CITY OF ALBUQUERQUE

RE: Lot 21 Block 9 Unit 18, S.A.D. 228

6500 Canavio Pl. NW Grading and Drainage Plan

Engineers Stamp Date 4-11-17 (D10D003I21)

STALLS - MAR	WAN — GRADIN	G & DRAINAGE	PLAN	
	LOT 21, VOLCANO				
011 01 /					MLXICO
CITY OF A	LBUQUERQUE, BI	FRNALILLO COL	INTY	NEW	MEXICO

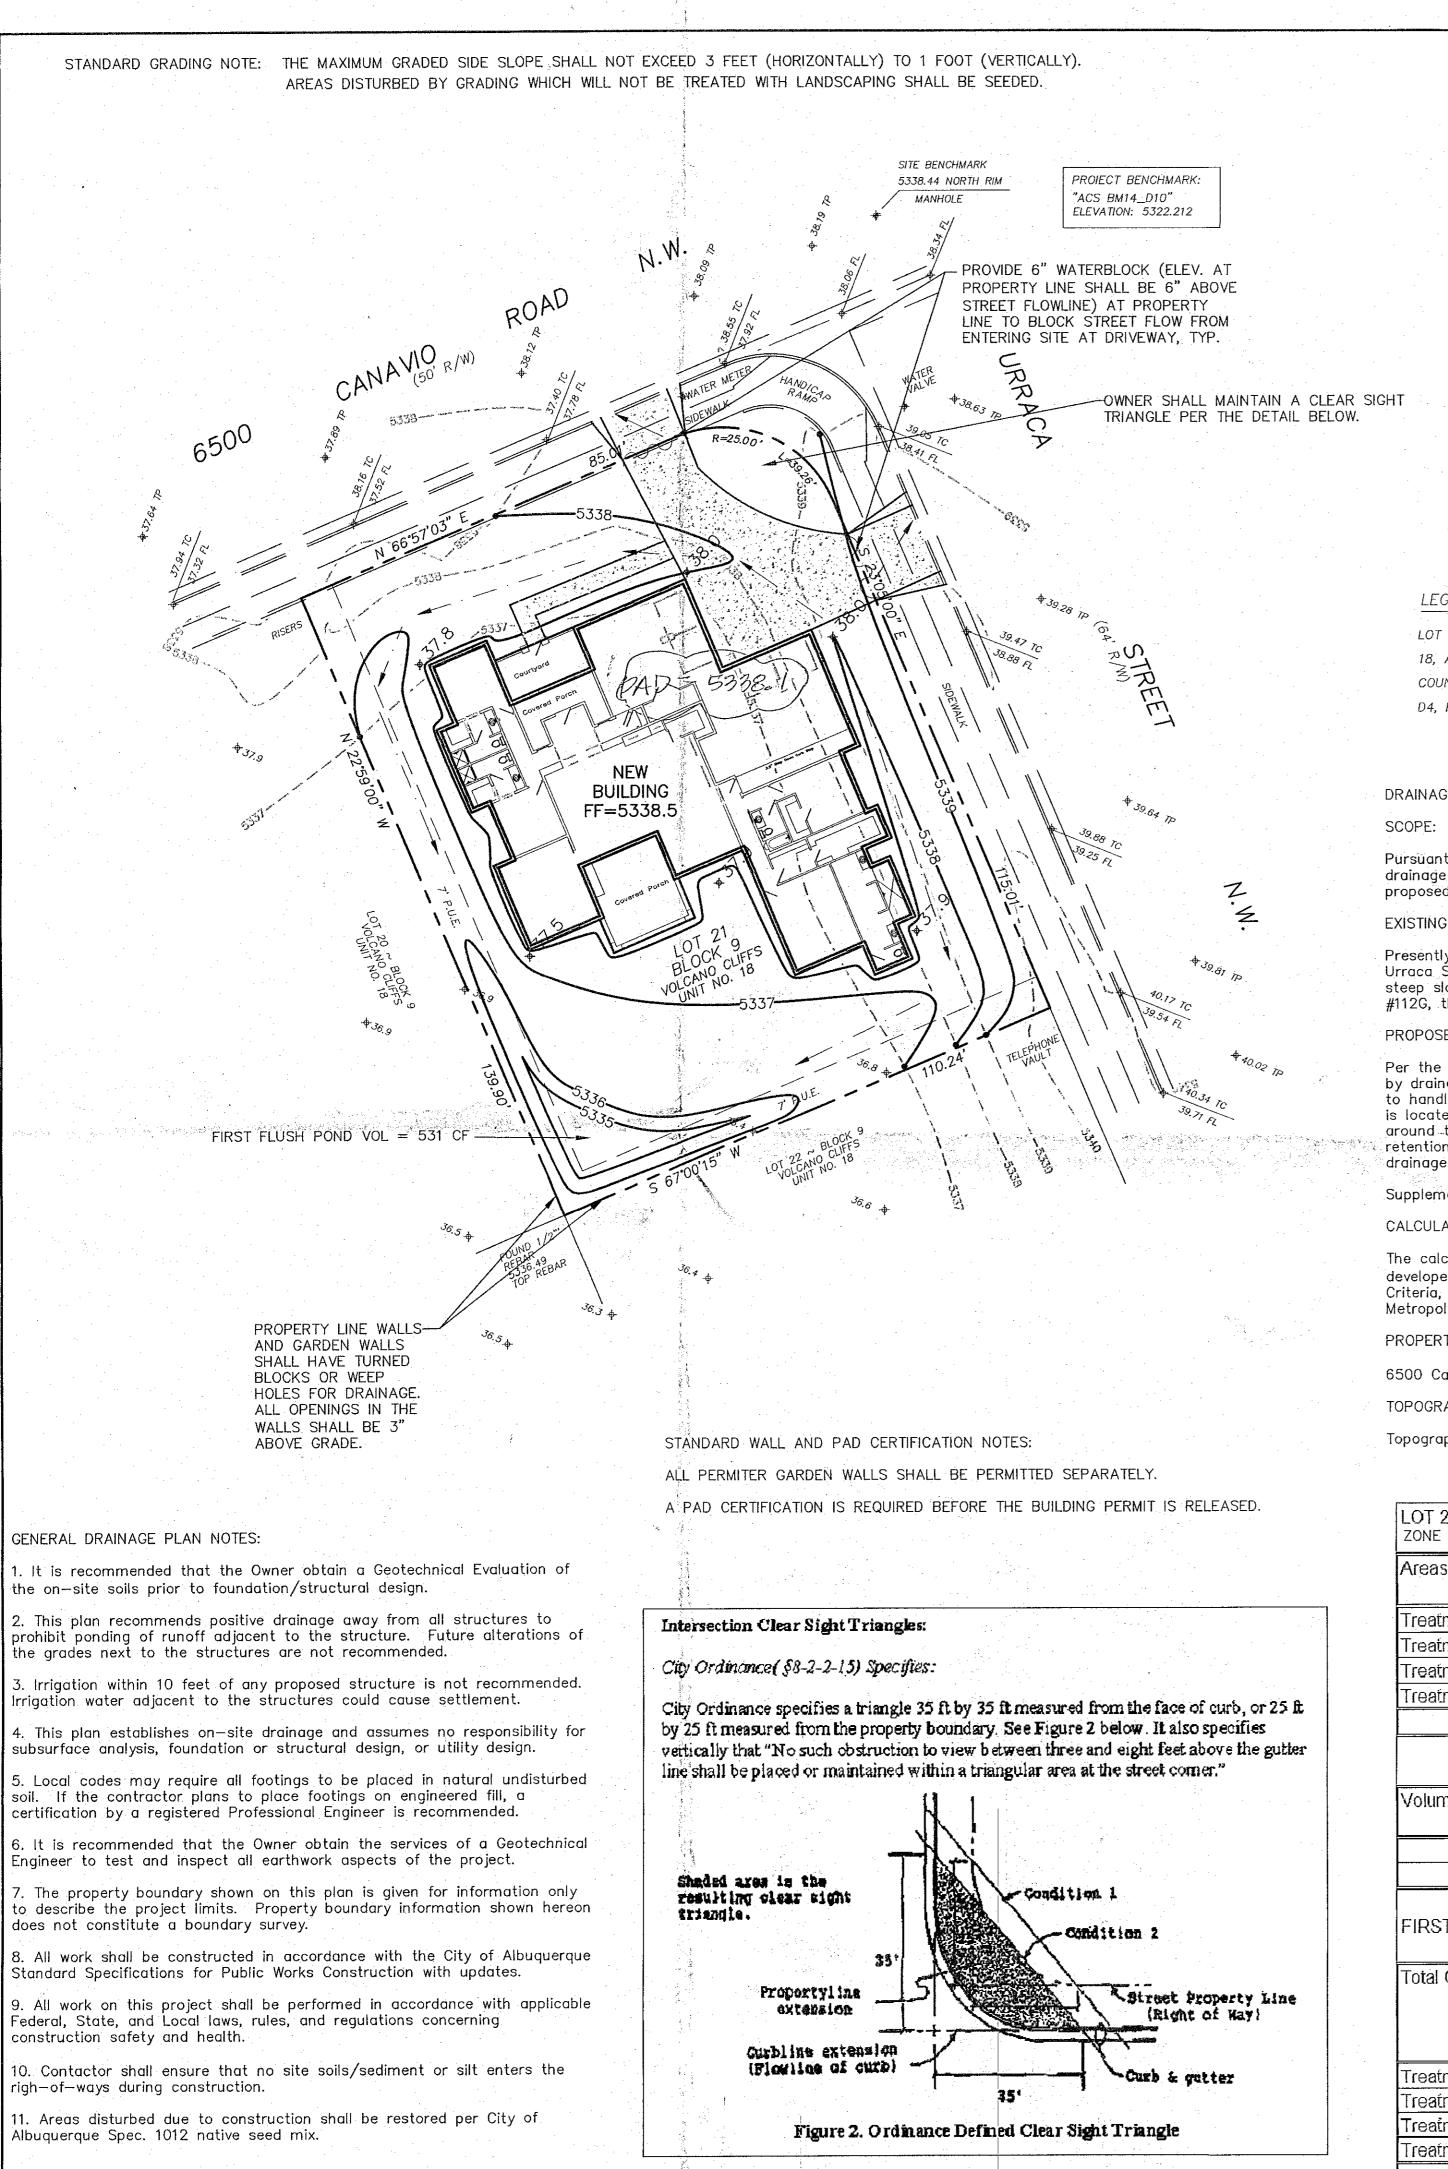
Based upon the information provided in your submittal received 5/16/17, this plan is approved for Building Permit.

Please have the owner/builder attach a copy of this approved plan, to the construction sets in the permitting process prior to sign-off by Hydrology. Reiterate to the Owner/Contractor that a separate permit for a garden/retaining wall must be obtained, with the approved G&D plan dated 4/11/17.

Prior to Certificate of Occupancy release, Engineer Certification per the DPM checklist of this plan will be required.
